MITSUBISHI SERVICE PUBLICATIONS TRANSMITTAL

SN 162/32-021

Main Landing Gear Leg Fitting Lugs Detail Inspection

SUBJECT: Main Landing Gear Leg Fitting Lugs Detail Inspection

Figure 1: LH MLG Leg Fitting (P/N 030A-32315-1)

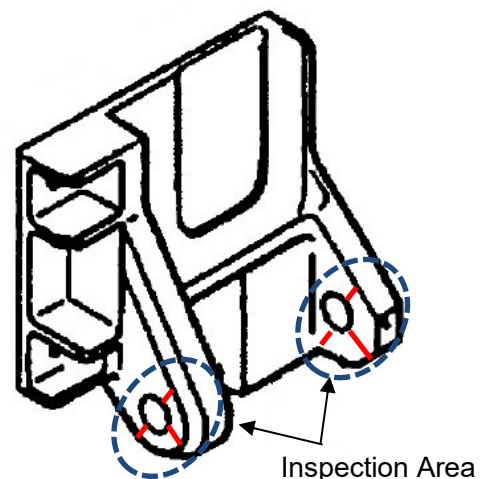
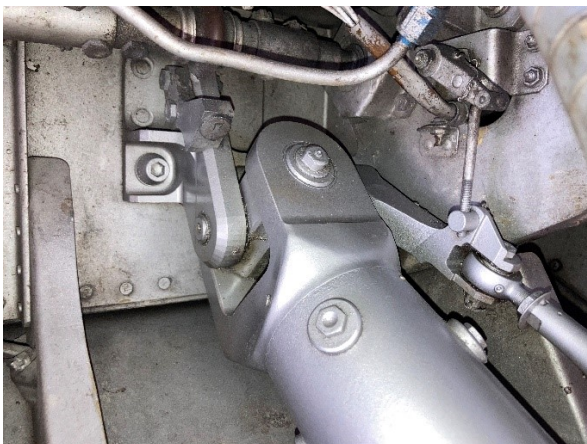
Mitsubishi Heavy Industries, Ltd. (MHI) issued Service News No. 211 (JCAB / A2PC) and No. 160/32-020 (FAA / A10SW), dated July 1, 2024, encouraging visual inspection of main landing gear (MLG) leg fittings, P/N 030A-32315-1/-2, on long body aircraft during periodic inspections. Since the release of the Service News, MHI has received additional reports of cracked fitting lugs found during routine inspections. Substantial damage to the fuselage can result from failure of fitting lugs during normal operations.

While a non-destructive inspection method is being prepared, MHI requests that each long body airplane owner and/or operator perform a detailed visual inspect and a dye penetrant inspection for any cracks in or around the lug portion of the fittings before the next flight and during the next periodic inspection. Areas to be inspected are indicated in Figure 1 below. Additional potential crack locations are highlighted. Also, it is important to apply lubrication to the fittings through grease ports in accordance with instructions in the applicable Maintenance Manuals.
